April 1, 1996

Re: Relocation of Additional Extraction Wells
Groundwater Treatment Project - Lot 203
MCB Camp Lejeune - D.O. 0015
Contract N62470-93-D-3032

From: Dan Fisher
To: Bill Mullen/LANTDIV, Lance Laughmiller/LANTDIV
Subject: Well Location Justification

Shallow Well Locations -- Site 82 MCB Camp Lejeune (82-104)

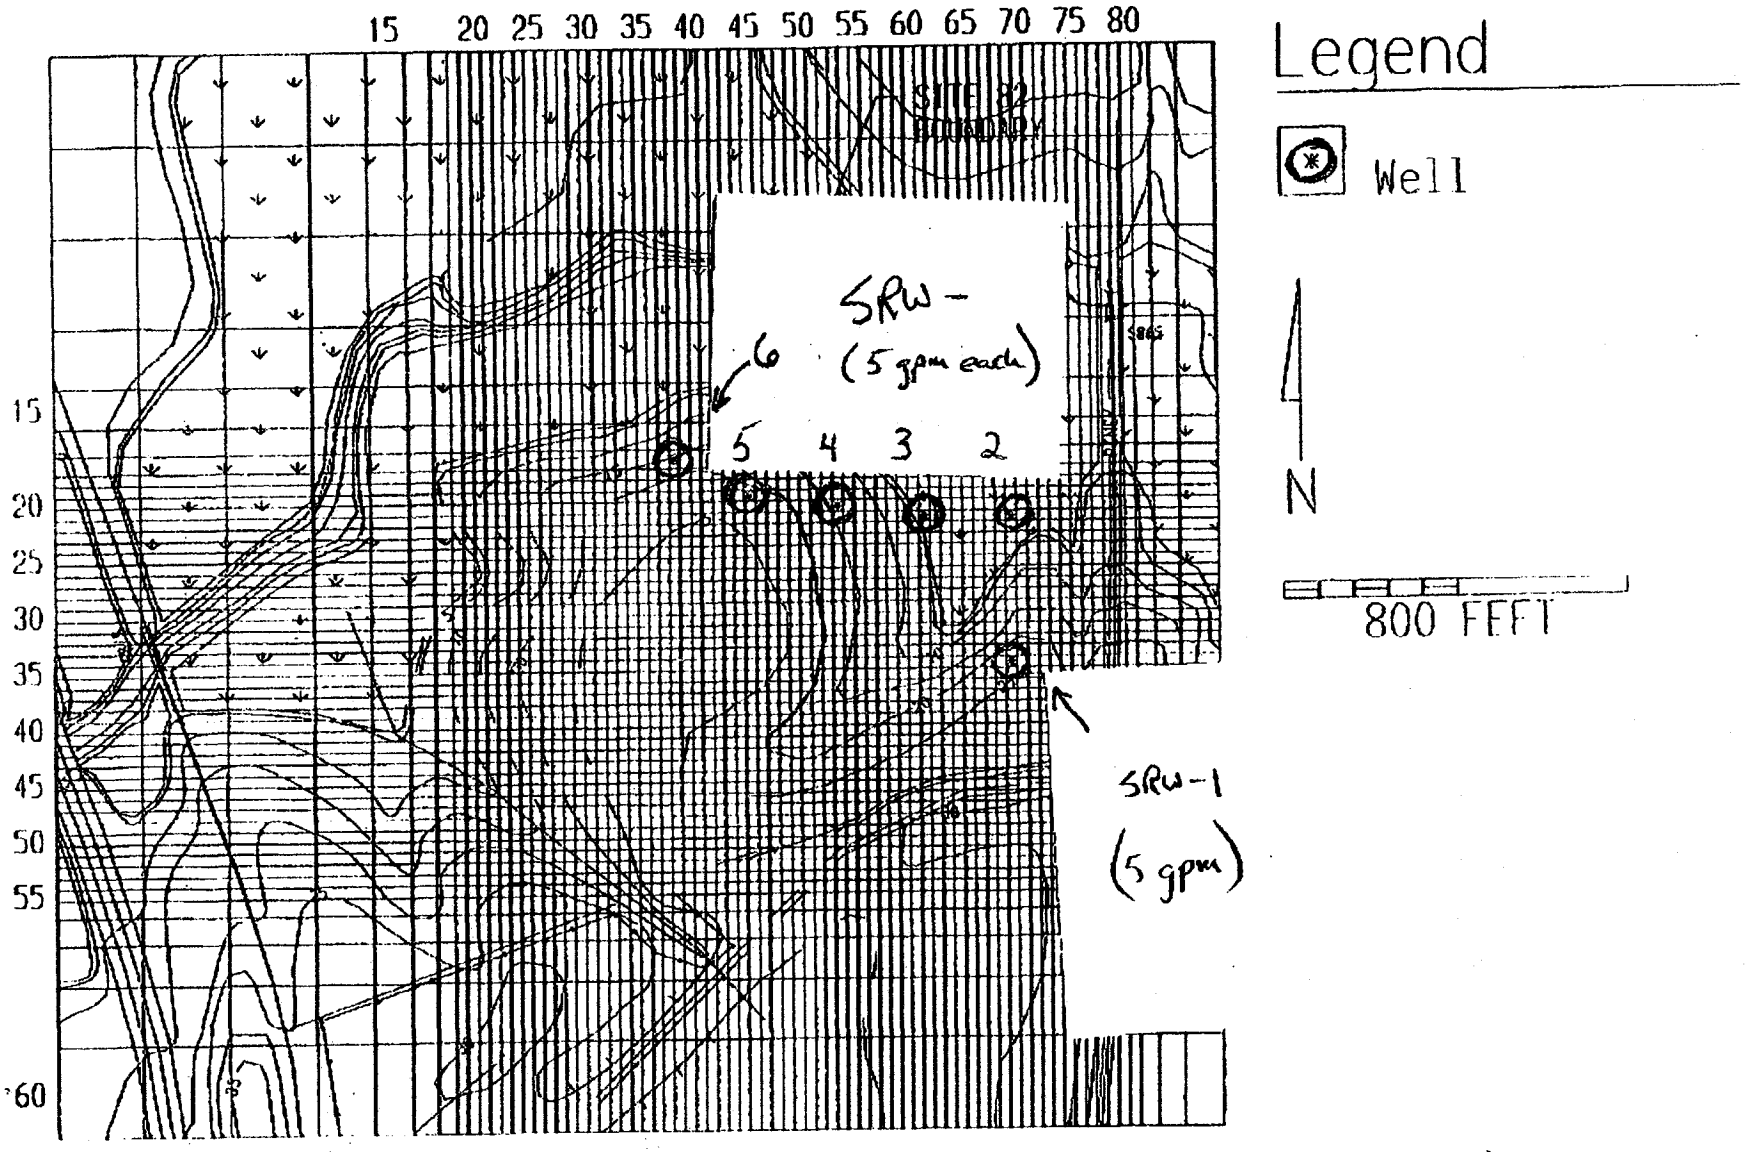
The well spacing was determined by placing the wells downgradient of the bulk of contamination in the model, running the model and viewing the results using MODPATH. In several runs, it was apparent that the well spacing was either too wide (evidenced by "gaps" or leaks in the hydraulic barrier) or too close (resulting in unnecessary pumping). The final locations reflect the balance of closing the gaps while minimizing pumping.

SRW-1	E	2,503,435	N	348,298	(EXISTING)
SRW-2	E	2,503,440	N	348,640	
SRW-3	E	2,503,240	N	348,640	
SRW-4	E	2,503,030	N	348,660	
SRW-5	E	2,502,850	N	348,680	
SRW-6	E	2,502,670	N	348,760

Shallow Capture Zones SRW-1 thru 6 @ 5 GPM (82-104)

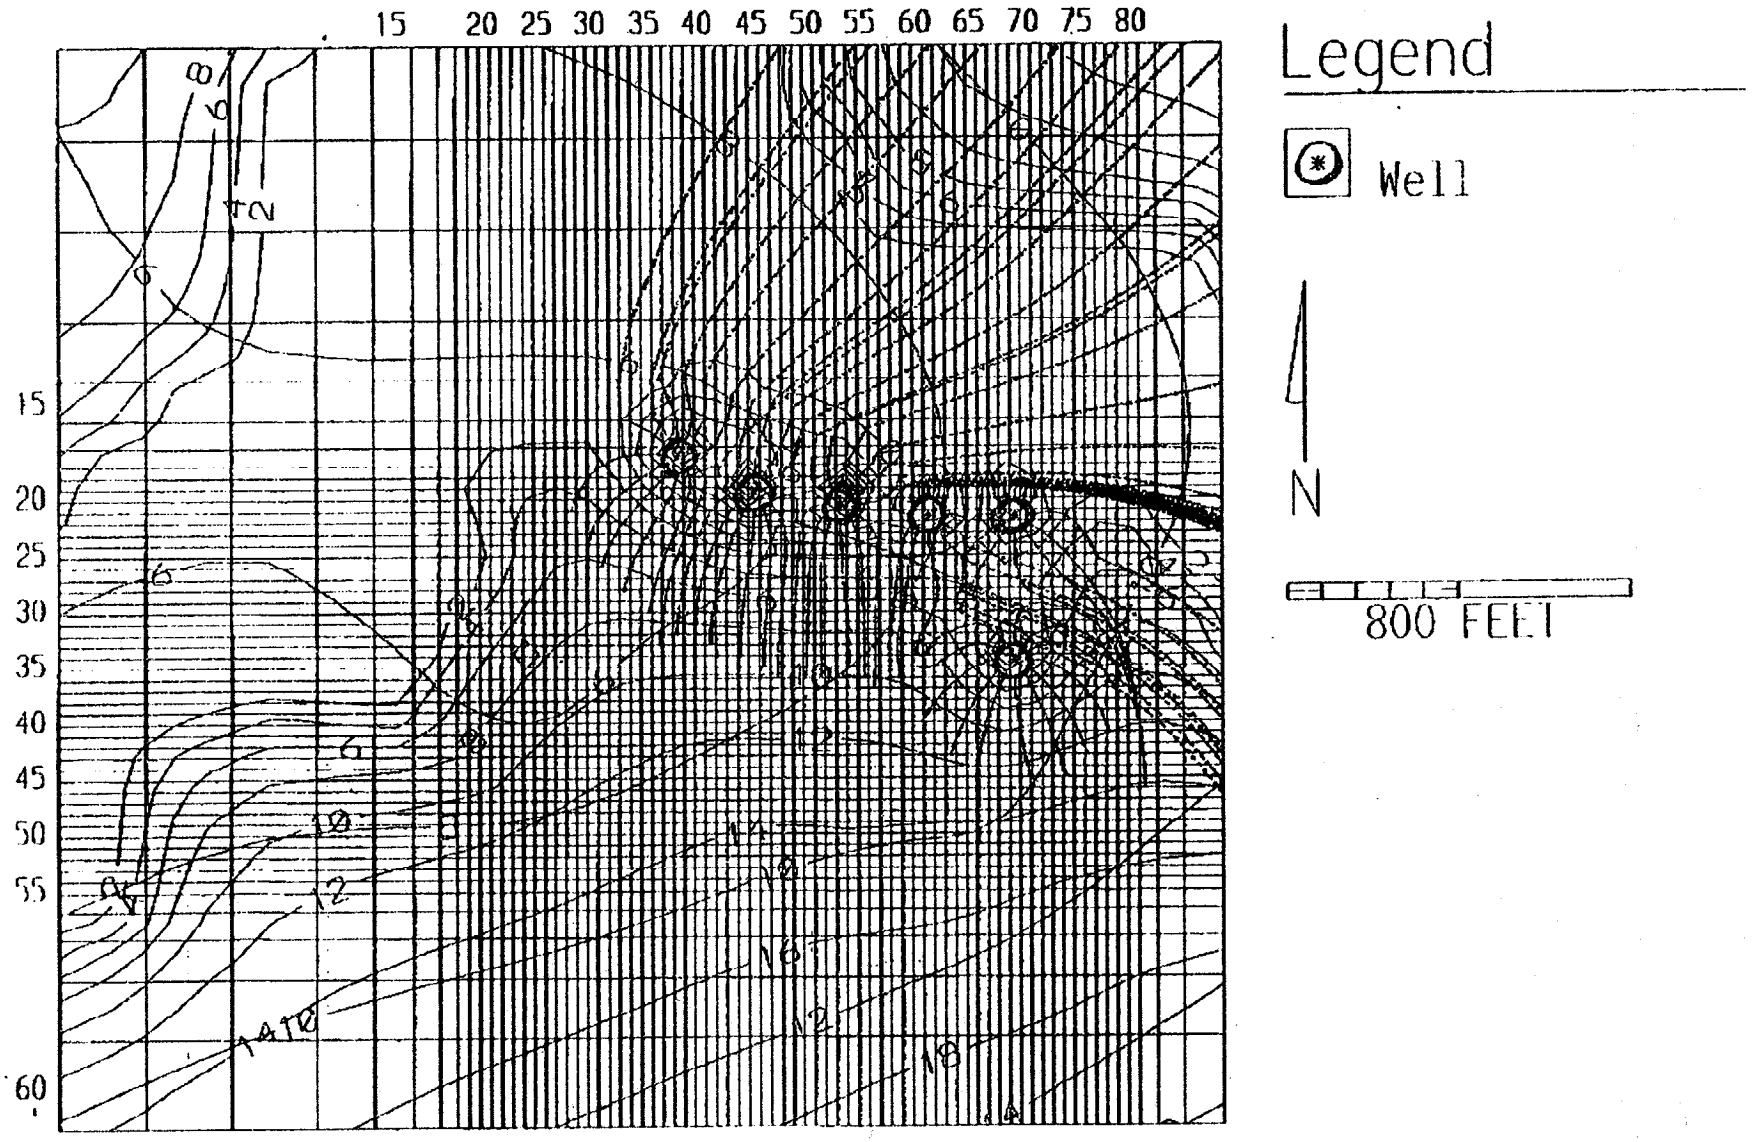
The five new shallow wells were estimated at 5 gpm each (from the rate produced by SRW-1 during the pumping test).

The deep capture zones are much wider than those of the surficial. This is mainly due to the larger sustainable pumping rate in the Castle Hayne. This is the explanation as to why the deep wells are so much farther apart than the shallow wells. Also the configuration of the wells is different because of different flow patterns in the shallow (which generally follows topography) than in the Castle Hayne (generally west-northwest toward the regional groundwater discharge point -- the New River). The line of shallow wells perpendicular to flow lies east west (flow is north toward Wallace Creek) and the "line" deep wells trends NE to SW to catch the NW flow.

Deep Well Locations -- Site 82 MCB Camp Lejeune (82-104)

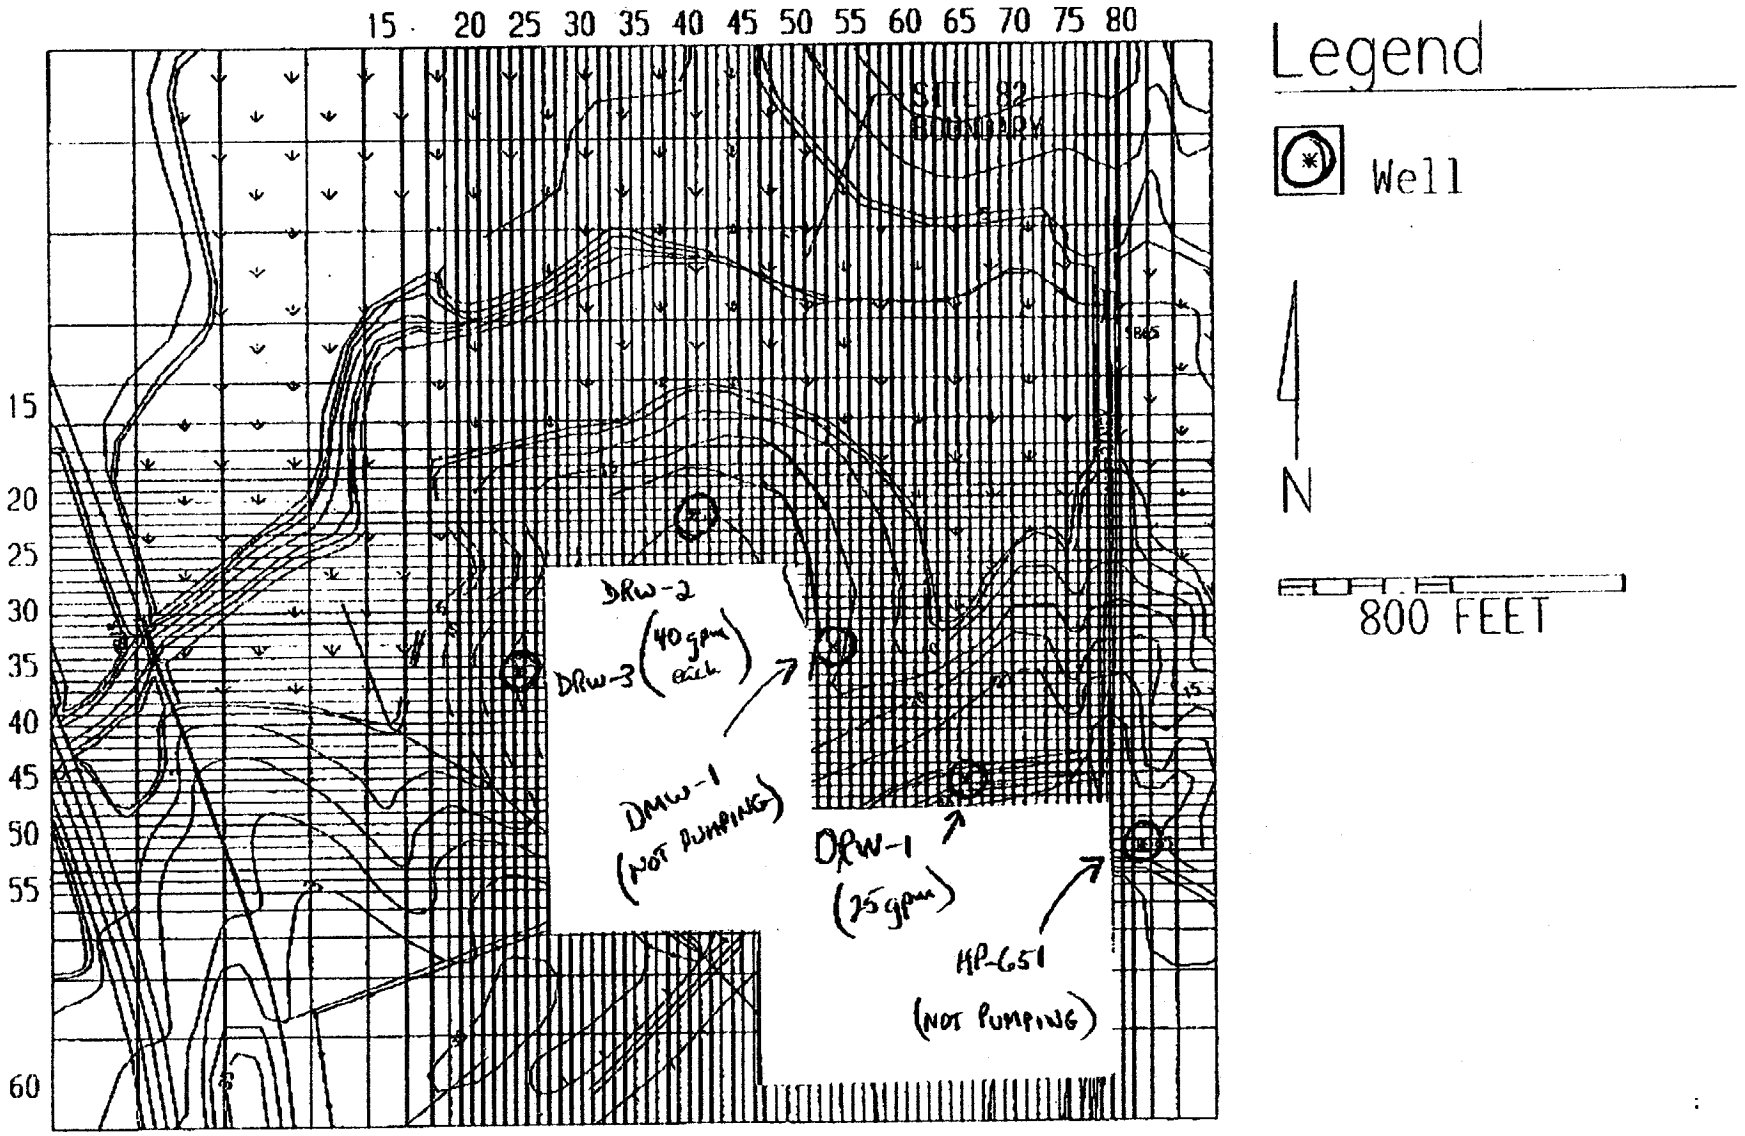
DRW-1	E	2,503,346	N	348,028	(EXISTING)
DRW-2	E	2,502,720	N	348,630	
DRW-3	E	2,502,320	N	348,280	
DMW-1	E	2,503,050	N	348,330

Deep Capture Zones DRW-1 @ 25 GPM; DRW-2 & 3 @ 40 GPM (82-104)

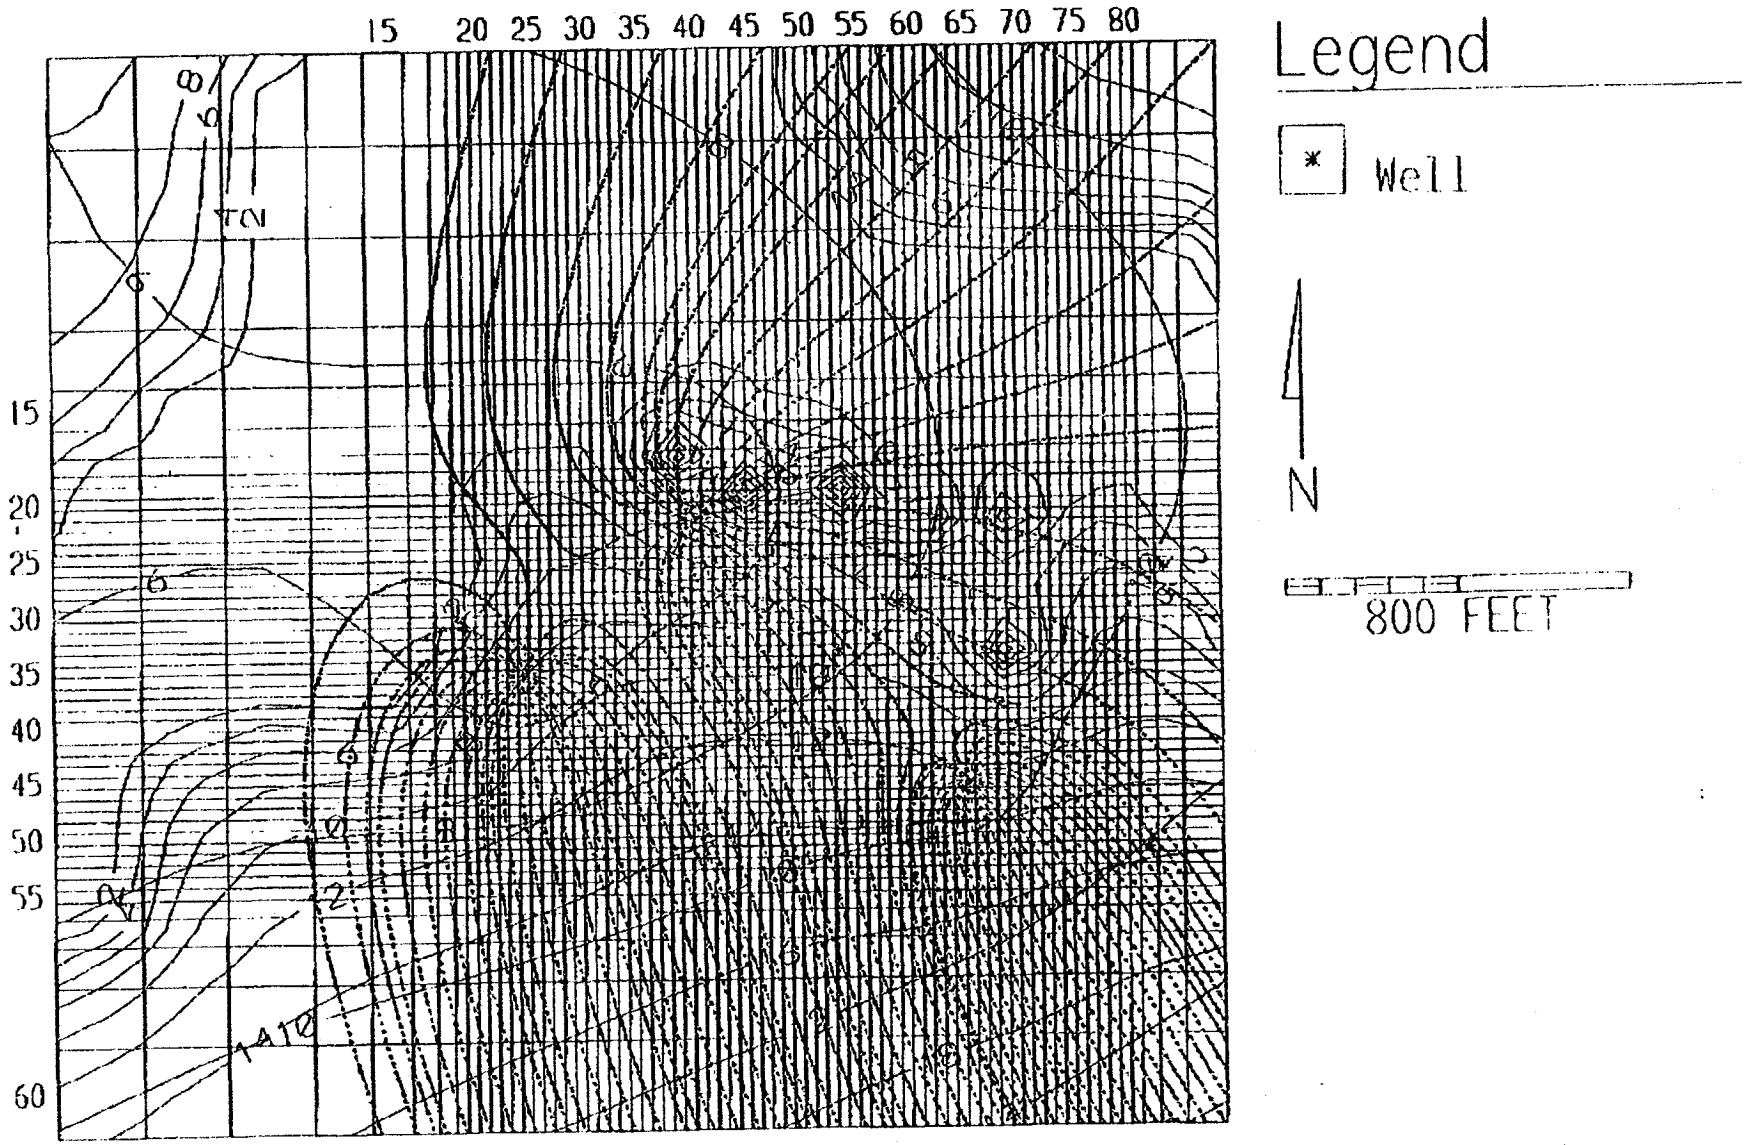
The width of the capture zones around each extraction well determine the well spacing necessary to provide hydraulic capture. The two new deep wells (DRW-2 and DRW-3) were estimated to produce about 40 gpm each. This is greater than the current rate of DRW-1 (25 - 30 gpm) due to assumed improved design and installation techniques. The sand pack of DRW-1 was not completely installed due to sloughing into the bottom half of the 20 foot long screen. The screens in DRW-2 and DRW-3 will be 30 feet long and close supervision of their installation is highly recommended. A skilled mud rotary driller will be necessary.

The depth of the deep wells is in line with the prevailing notion of "not drawing contamination further downward," and while this is a desirable goal, it necessarily limits the available drawdown, and hence, the amount of water pumped by the system. The original estimates of deep well yield were based on the production of HP-651 (about 250 gpm), but the new extraction wells are screened shallower (80 to 110 feet bgs versus 125 to 300 bgs for HP-651) and are smaller in diameter (6 inch versus 10 inch) than the production well. The new estimates of pumping in the deep wells (40 gpm) are based largely on the real rate from DRW-1
